### MINNETONKA PLANNING COMMISSION July 11, 2019

Brief Description	Resolution approving the preliminary plat of CONIFER HEIGHTS, 6-lot subdivision of existing properties at 5615 Conifer Trail and 5616 Mahoney Ave
Recommendation	Recommend the city council adopt the resolution approving the preliminary plat

## Resolution approving the preliminary plat of CONIFER HEIGHTS, a six-lot subdivision, at 5615 Conifer Trail and 5616 Mahoney Ave

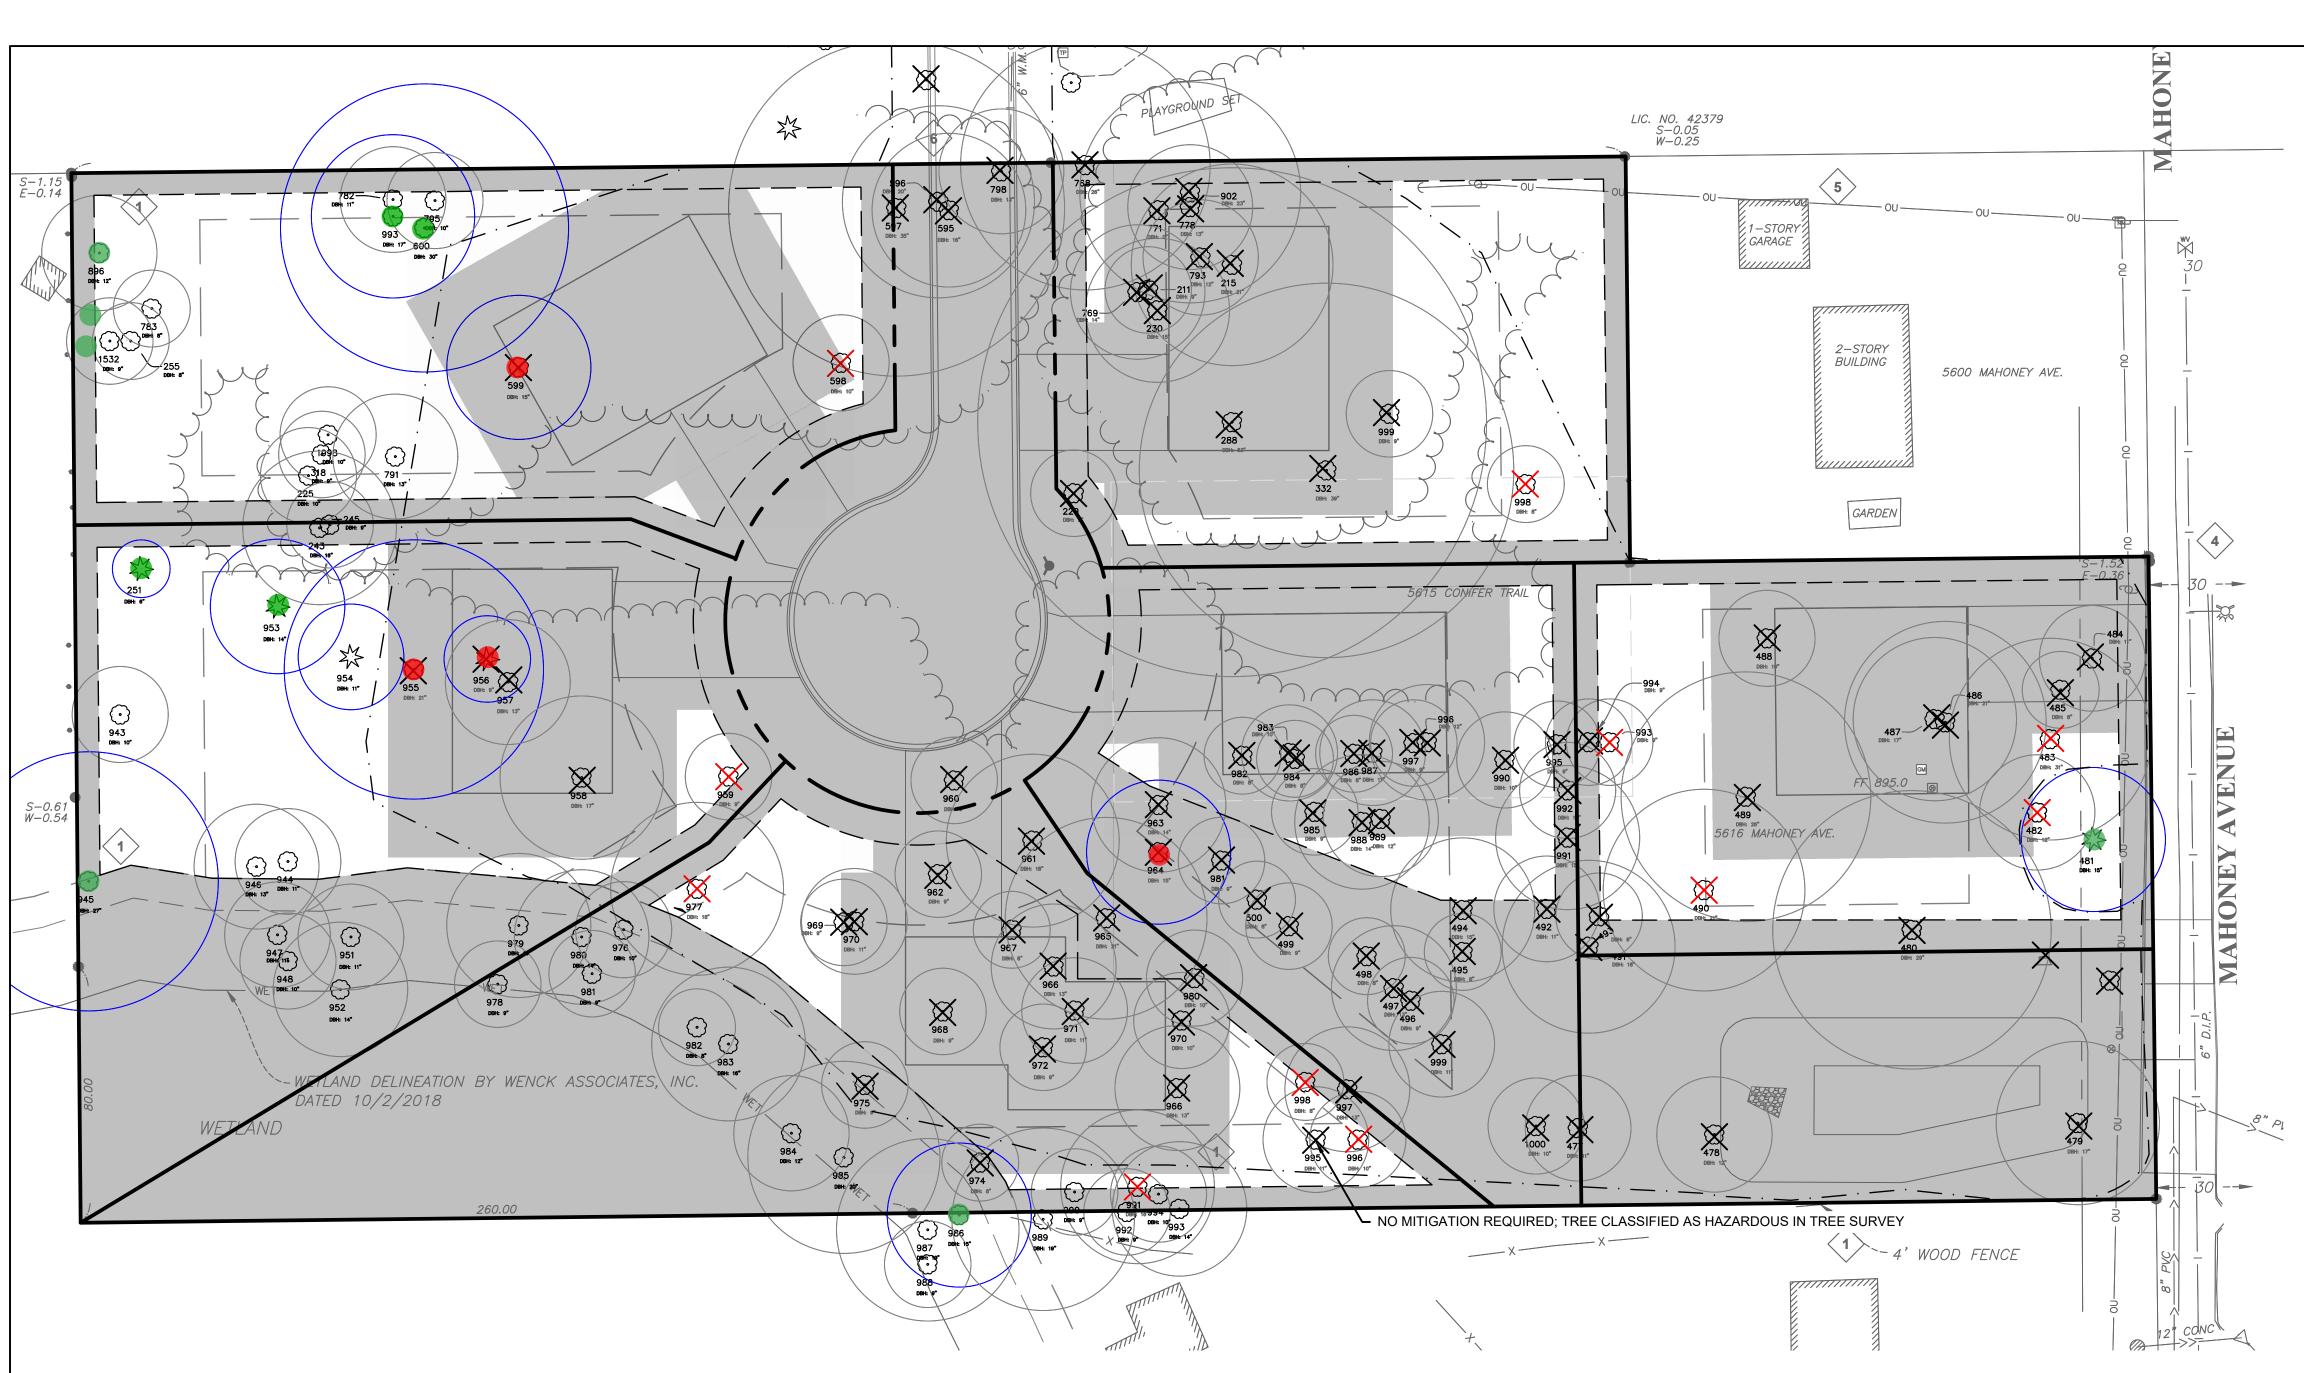
- Locate the STMH 100 in curb line rather than in the roadway to connect to the existing storm sewer.
- Storm pipe sizing cannot decrease in size in the downstream direction. Maintain 24-inch.

- Bioretention basin must drawdown in 48 hours. Maximum ponding depth is 18 inches.
- c. Final utility plan must:
  - use the updated detail plates.
  - provide profiles of utilities for review of grades and depth.

- Indicate that the water main pipe is DIP.
  - Show service locations and locate the water services outside of the driveway.
  - Install isolation valve outside of c-d-s for green space isolation.

- Install a gate valve on the southern leg of Mahoney Ave connection.
  - No water services may come from the side yard, must be located outside of the greenspace isolation valves.

- Illustrate unused water service pipe on Mahoney Ave must be removed back to the main, with the corporation stop turned off

- Wet tap the 6-inch main on Mahoney Ave.
- Locate SSMH 2 to roadway in line with SSMH 1.
- Drop manhole structure to be outside drops.
- d. Final landscaping and tree mitigation plans must meet minimum landscaping and mitigation requirements as outlined in ordinance. However, at the sole discretion of natural resources staff, mitigation may be adjusted based on site conditions. In addition:

### TREE PRESERVATION SUMMARY

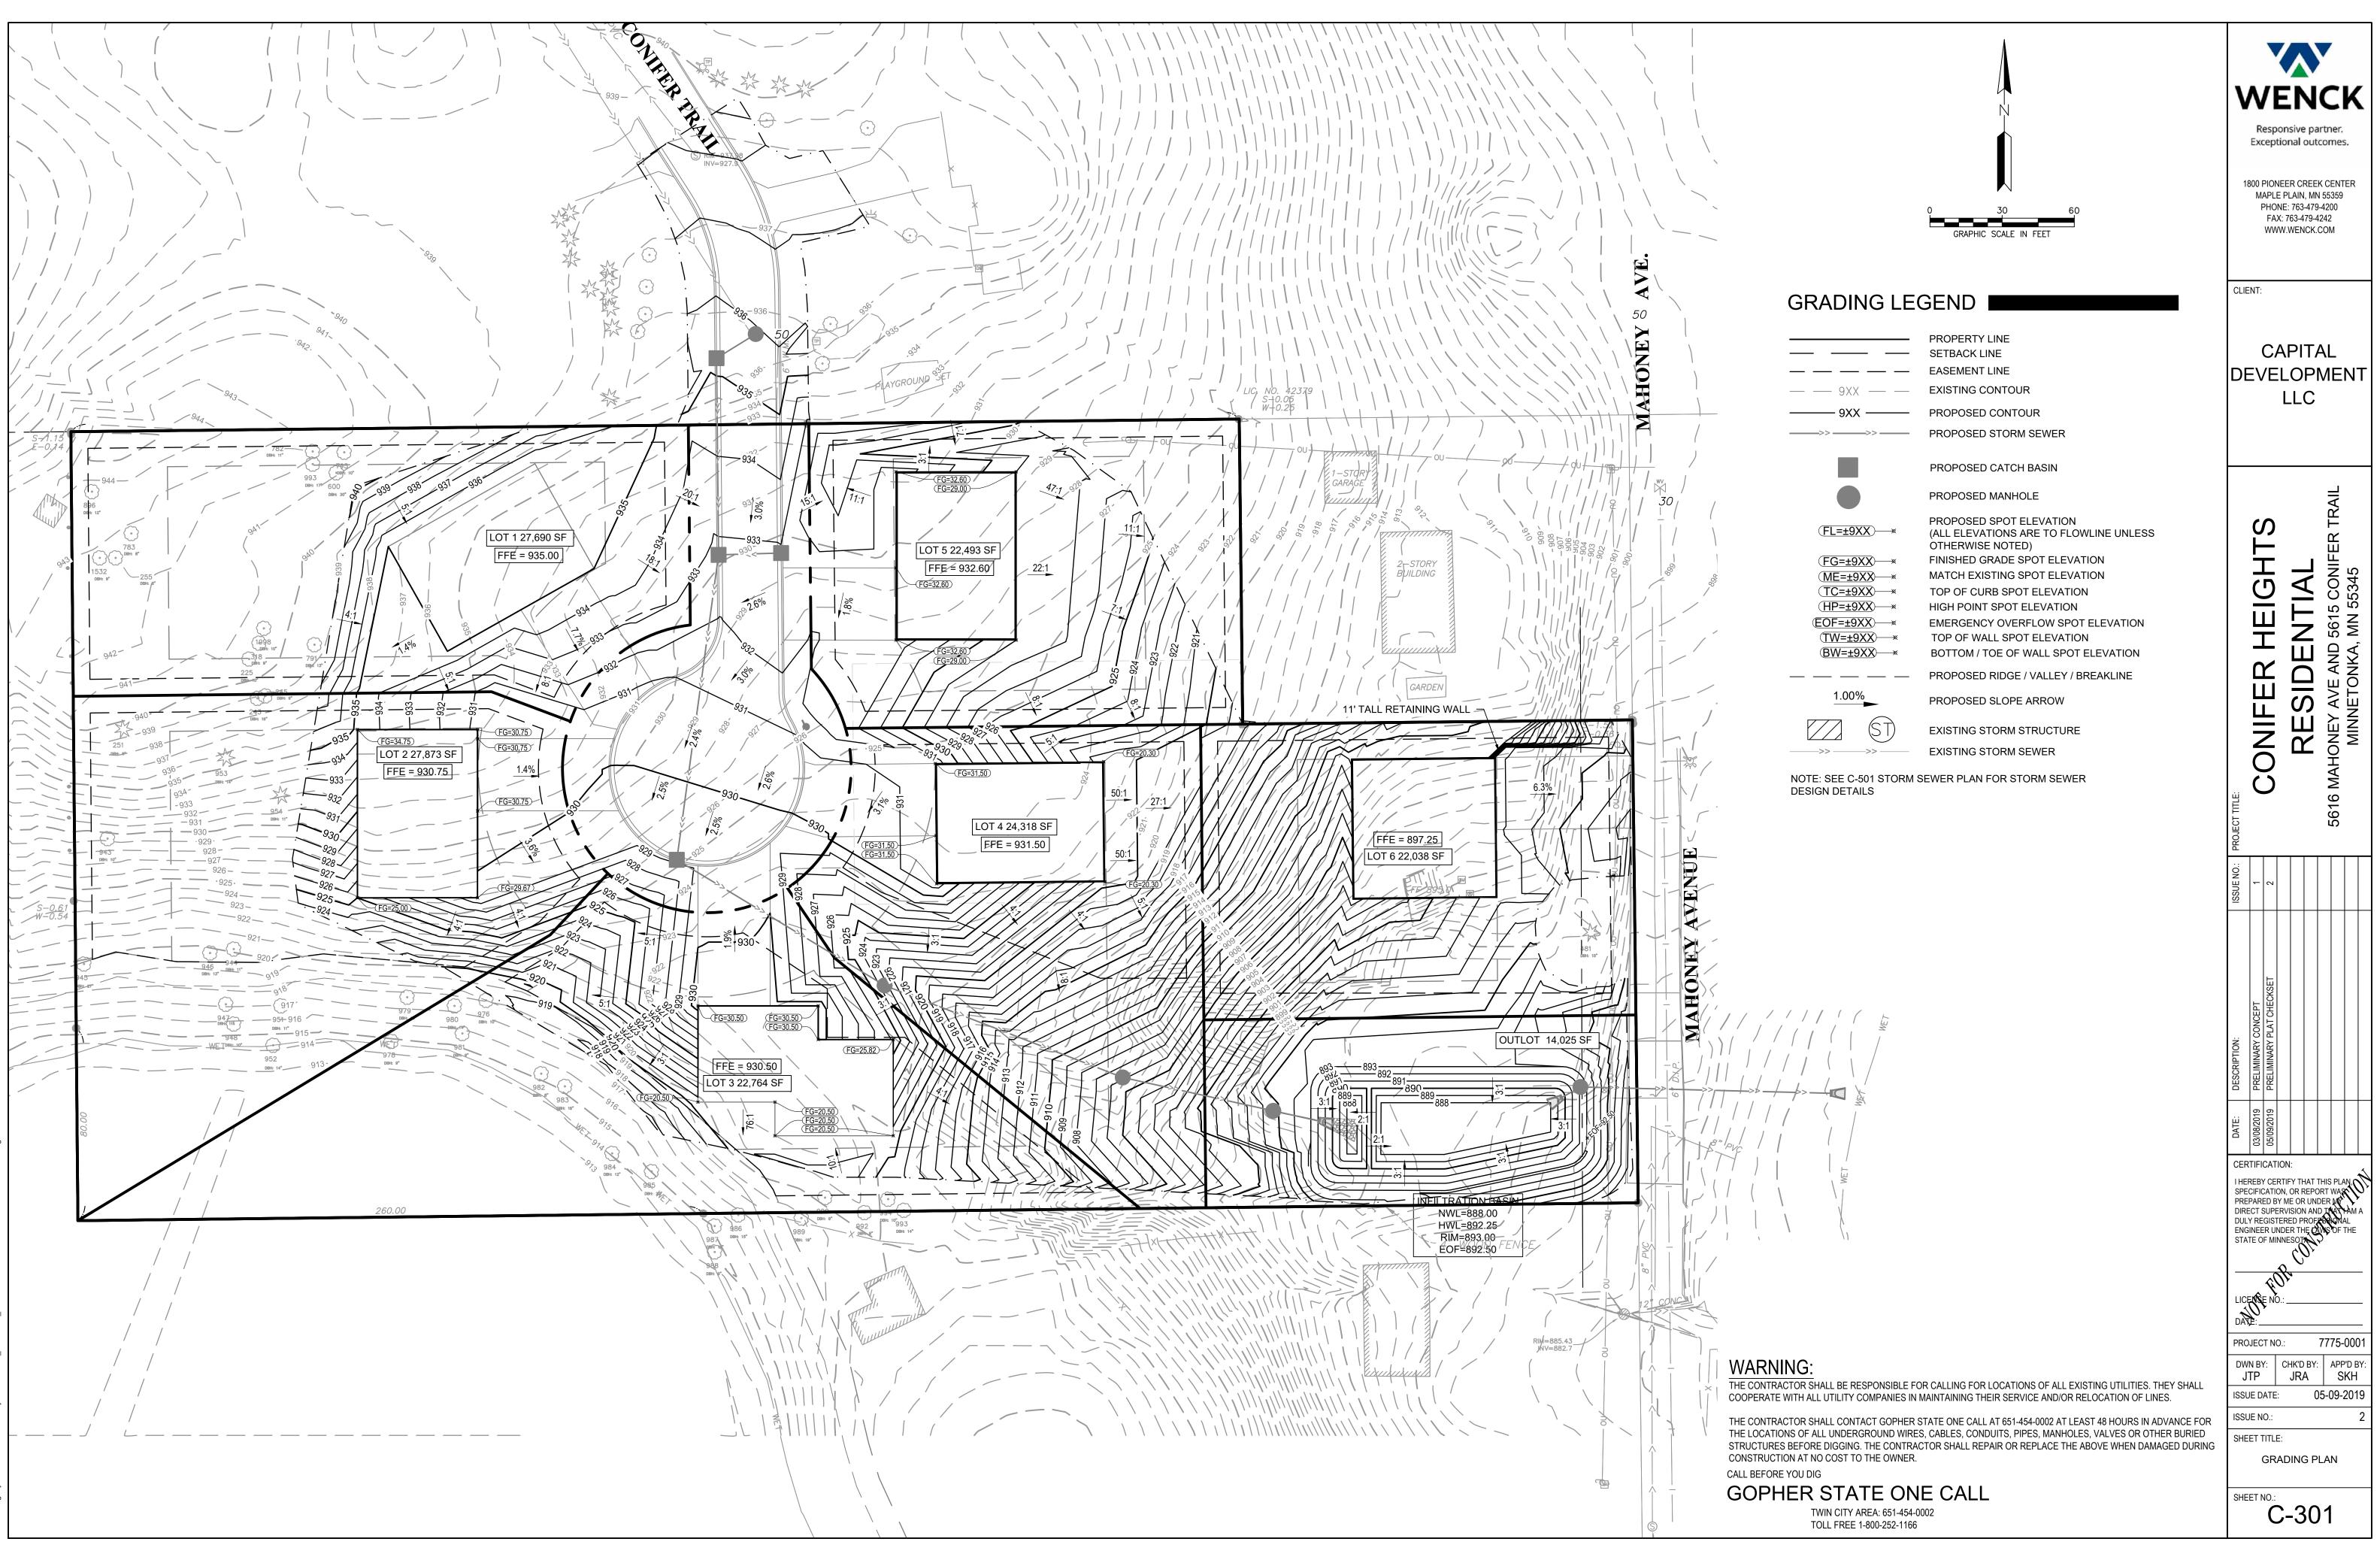
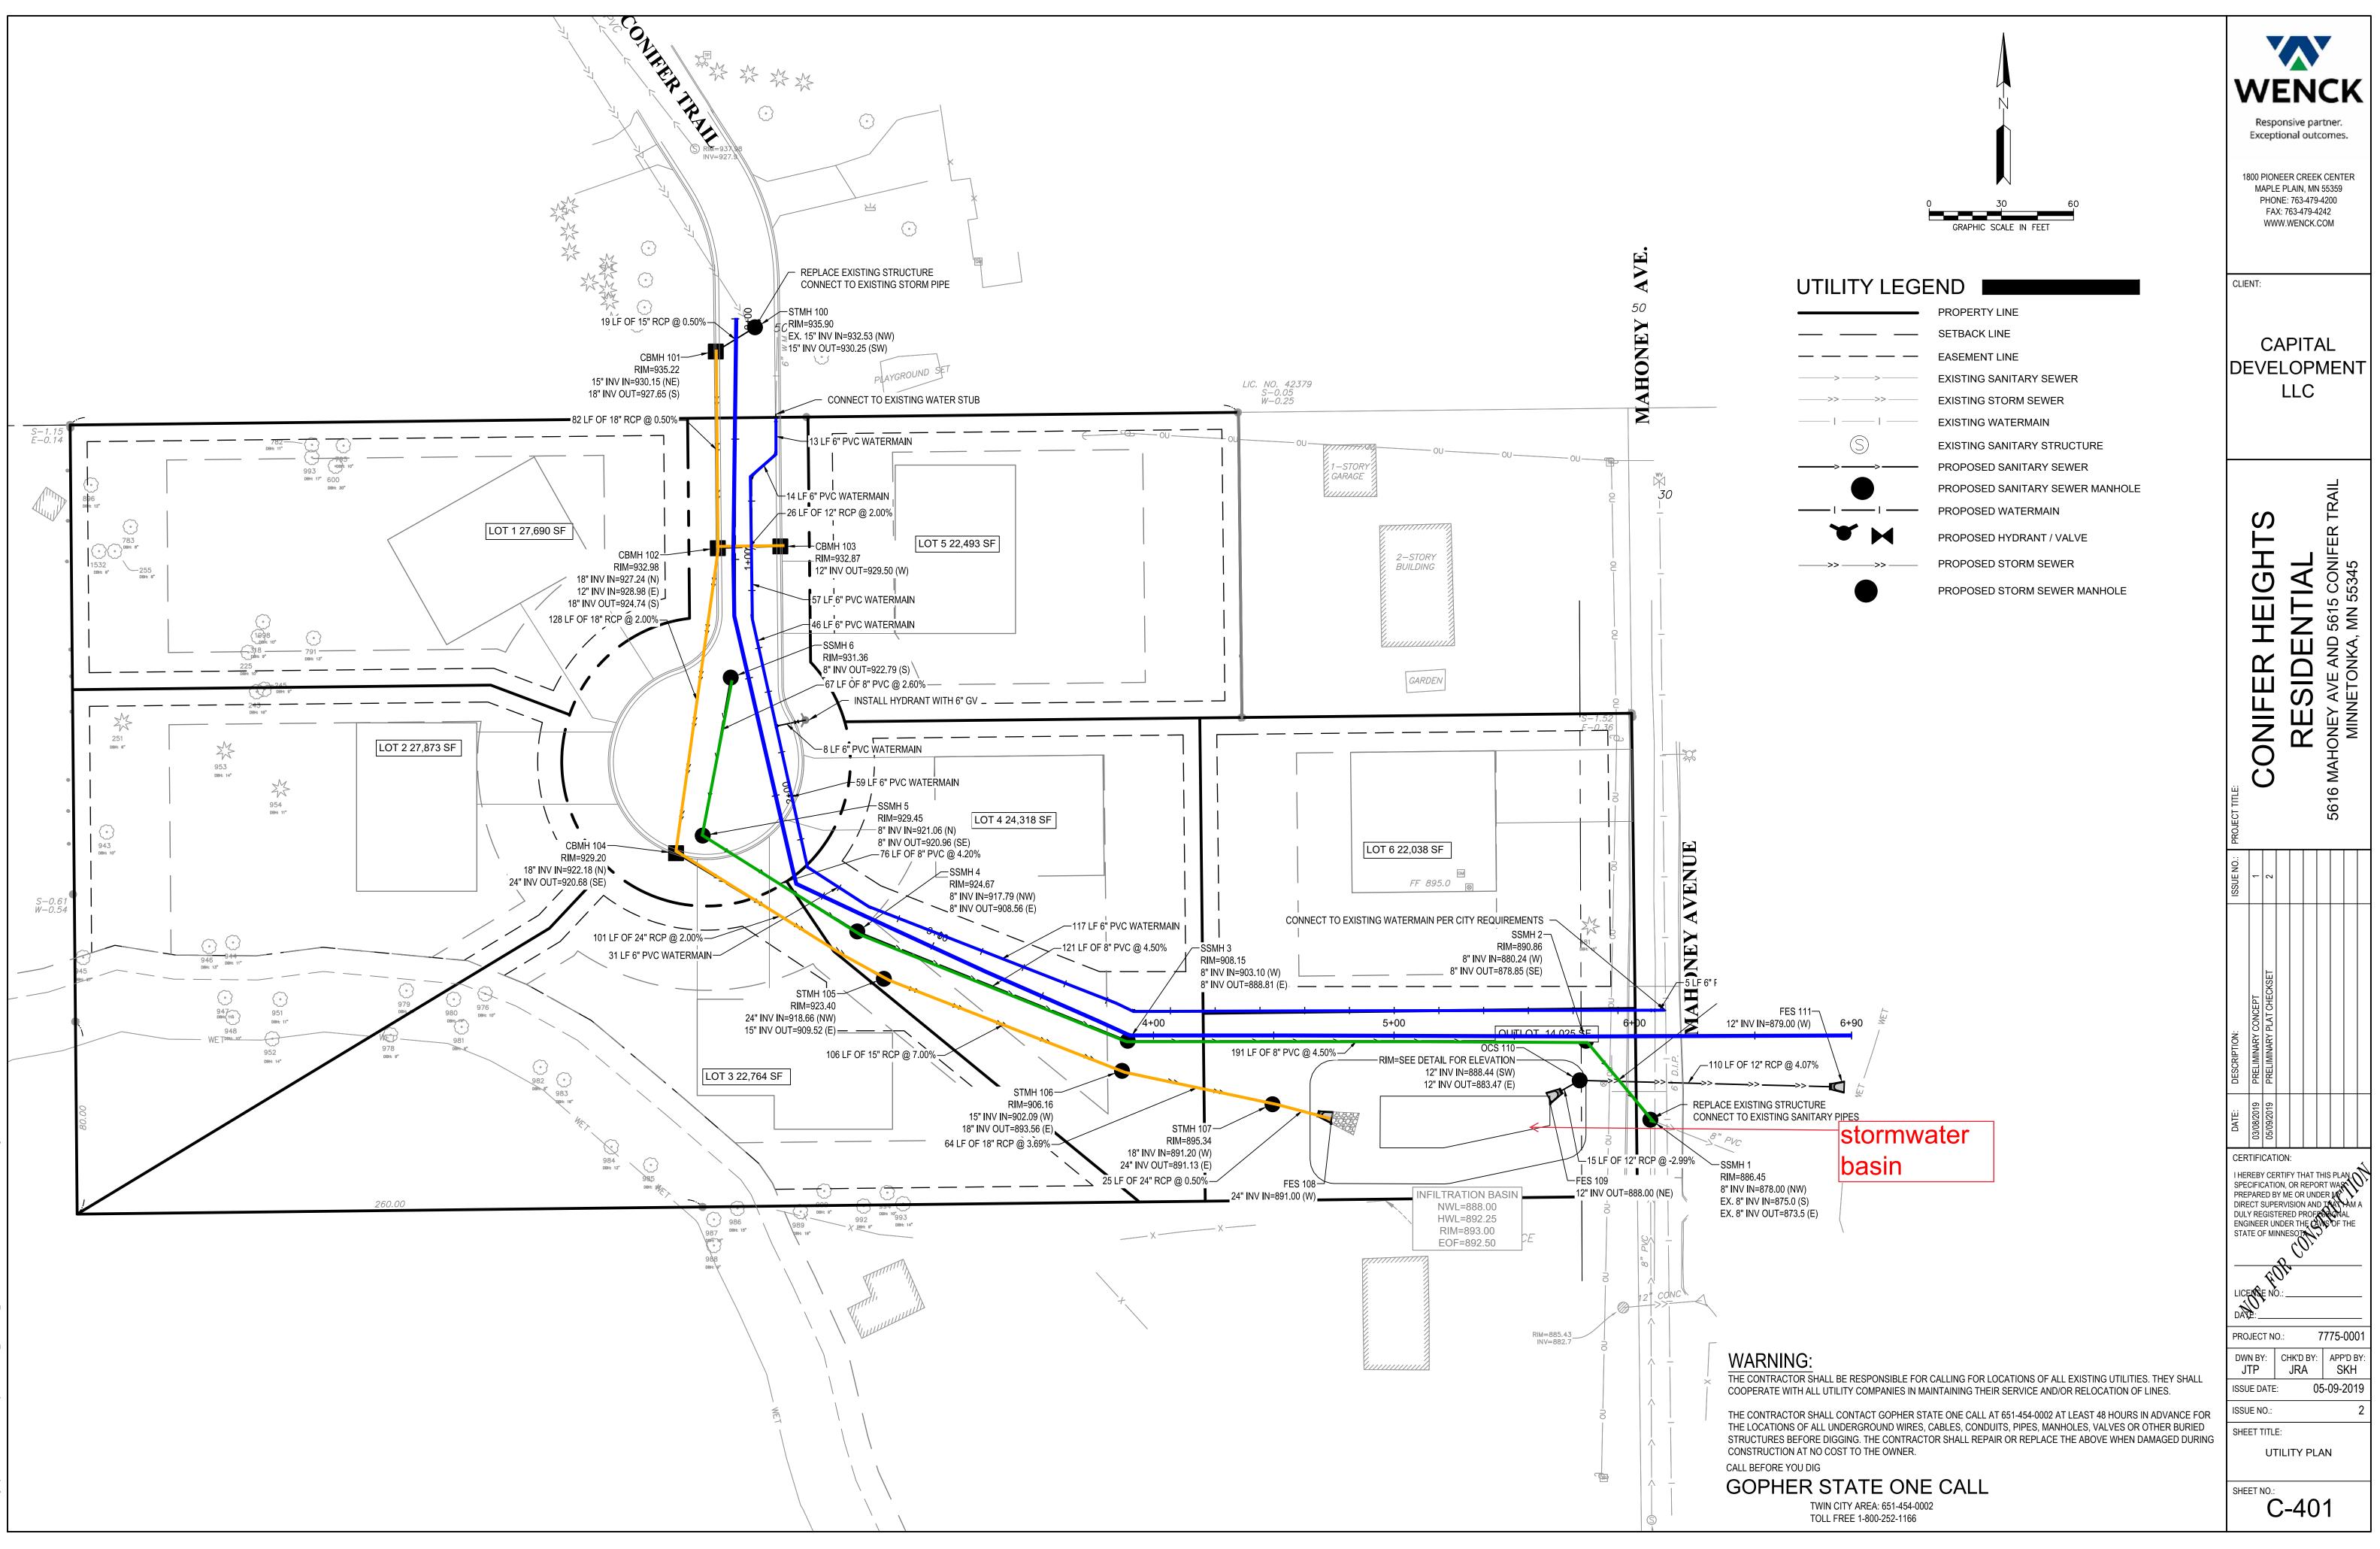
- No more than four high priority trees can be removed.
  - Based on the submitted plans the mitigation requirements would be 19, two-inch trees.
- 4) Individual letters of credit or cash escrow for 125% of a bid cost or 150% of an estimated cost to construct streets and utility improvements, comply with grading permit, wetland restoration, tree mitigation requirements, and to restore the site. One itemized letter of credit is permissible if approved by staff. The city will not fully release the letters of credit or cash escrow until: (1) as-built drawings have been submitted; (2) a letter certifying that the streets and utilities have been completed according to the plans approved by the city has been submitted; (3) vegetated ground cover has been established; and (4) required landscaping or vegetation has survived one full growing season.
